From:	Gonzalez, Christian
Sent:	Thursday, February 25, 2021 9:39 AM
То:	Cabrera, Suramy; Garcia, Dayron; Franc Rubio
Cc:	Tejera, Erick; Rodriguez, Steven; Cejas, Devin; Garcia, Adolfo; Ana Escagedo; Hernandez,
	Analyn
Subject:	Re: 665 Calatrava Avenue permit status

I passed by and inspected 665 Calatrava today and spoke with the homeowner Jaime. See attached photos of my finding.

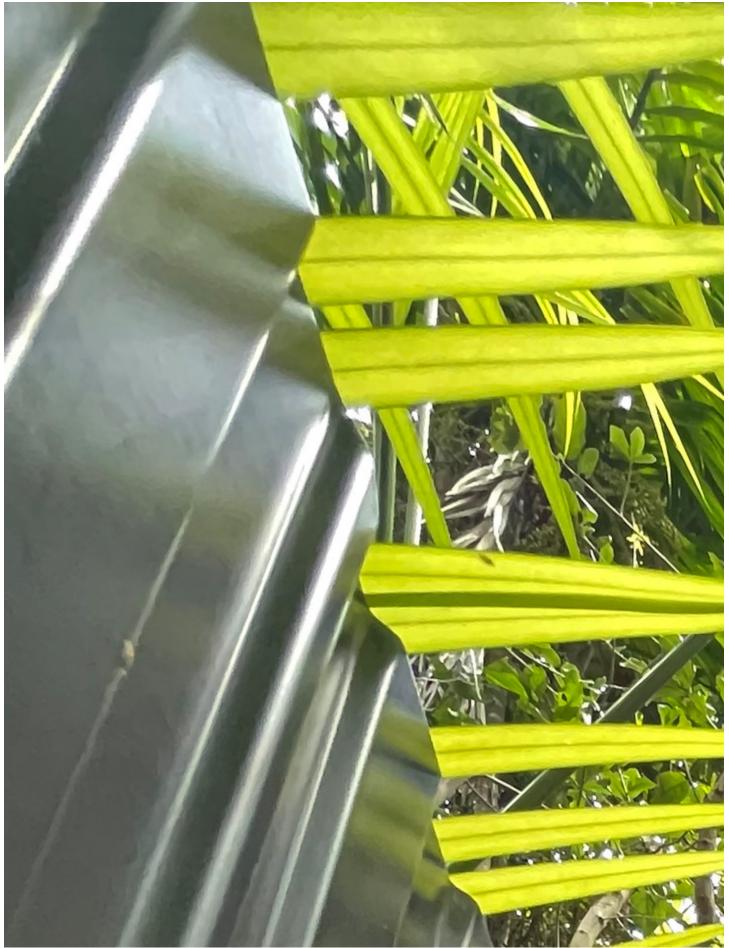
1) The structure appears to be more than 60SQFT.

2) The landscaping which is required to screen the structure has died. (Owner said he has already spoken with landscaper to replace the dead trees and will replace with Japanese Blue Berry trees.

3) There was no plumbing or electrical or mechanical units or installations within the playhouse.

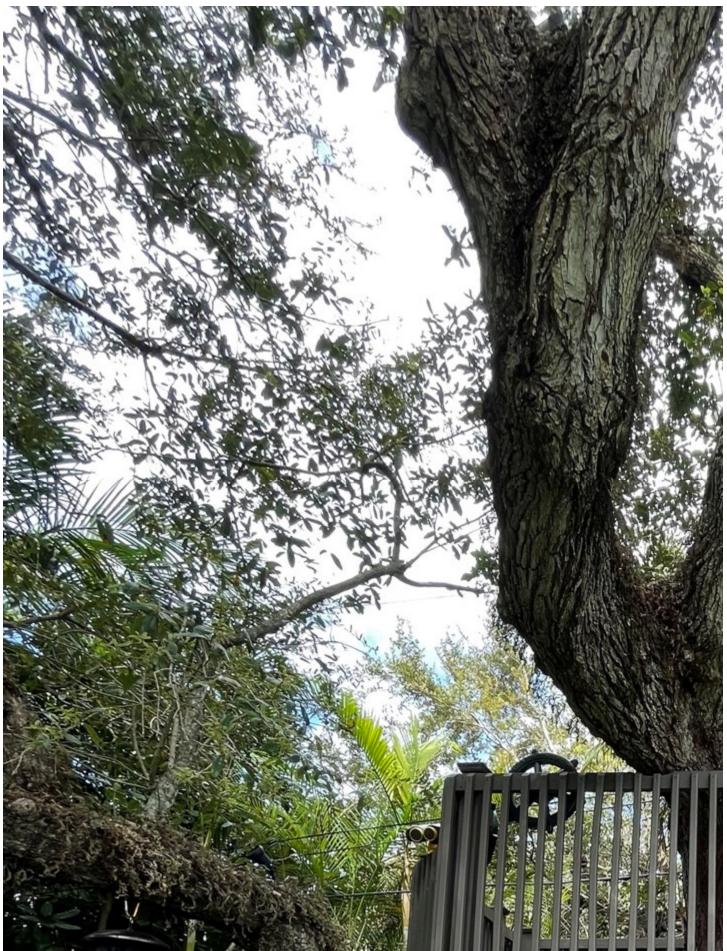
4) The setback from the property line is about 2FT.
